Service Bulletin

REF: JD 27/94

ALL JAGUAR AND DAIMLER MODELS WITH V12 ENGINES

12 SEALING OF BOLT THREADS - OIL SUMP SANDWICH PLATE

Fig. 1. XJ12 MODELS

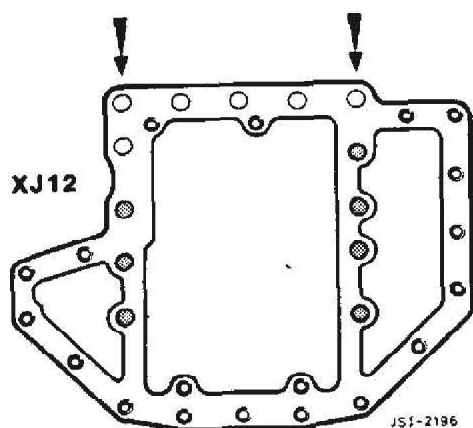
In addition to the possibility of oil leakage at either of the above gaskets, oil may also spread upwards along the threads of certain bolts which retain the sandwich plate and baffle tray. The heads of the bolts are in contact with oil, while the tops of the threads in the crankcase are exposed externally. In the event of the oil sump being removed to allow replacement of either gasket, the threads of the bolts concerned should be sealed by the application of 'Loctite 542' sealer.

The bolts concerned are identified by shading in Fig. 1 below and in Fig. 2 opposite.

Remove the bolts identified by shading; thoroughly clean and degrease them, using a suitable solvent; wipe or blow them dry.

Note: (9 bolts on XJS V12 engines; 7 bolts on XJ12 engines).

Using a suitable solvent and a 'bottle'-type brush, thoroughly clean out any residual engine oil from the threads in the crankcase; blow out the threads using an airline.

IMPORTANT: BOTH THE THREADS OF THE BOLTS AND THE THREADS INTO WHICH THE BOLTS ARE FITTED MUST BE THOROUGHLY DEGREASED, OTHERWISE THE 'LOCTITE' 542 WILL NOT CURE TO CREATE AN EFFECTIVE SEAL.

Using a clean cloth and/or a 'bottle'-type brush, apply 'Loctite Primer' to the threads in the crankcase. Allow to dry.

When refitting the sandwich plate retaining bolts concerned, apply 'Loctite 542' to the bolt threads.

Torque setting: 21-27 Nm.
